# Historical Architectural Review Board COA Preliminary Review Sheet

**HDC-2024-001114**

**Address: 523 Allen Street**

**Proposal: Installation of second floor balcony railing and supports.**

Proposed Railing (Applicant)

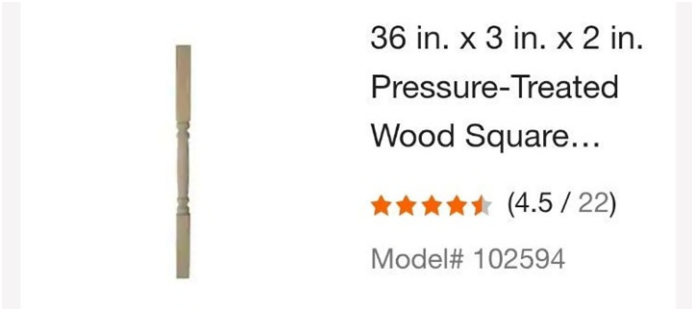
**Observations & Comments:** The proposed spindles for the railing are an appropriate replacement to the current condition. More information would be helpful to understand the configuration of the proposed railing system, including the orientation of the 2x4 framing shown in the photo "Proposed Railing." It would be appropriate if the construction of the railing maintains similar proportions to the original railing at the front porch, particularly that the framing is oriented horizontally at the top and bottom of the proposed spindles.

The current condition photo indicates additional posts supporting the balcony in addition to two original corner/intermediate posts. More information would be helpful to understand the intent of the proposed work; an appropriate approach would be to repair/replace posts in the original locations and remove intermediate posts that were later added as supplemental support.

- Railing assembly maintains similar proportions to the original railing at the front porch, and that the railings are constructed in a similar matter (2x framing is oriented horizontally at the top and bottom of the proposed spindles).
- Wood posts are repaired/replaced at the original post locations, and supplemental posts that were previously installed are removed.
- All wood elements are painted.
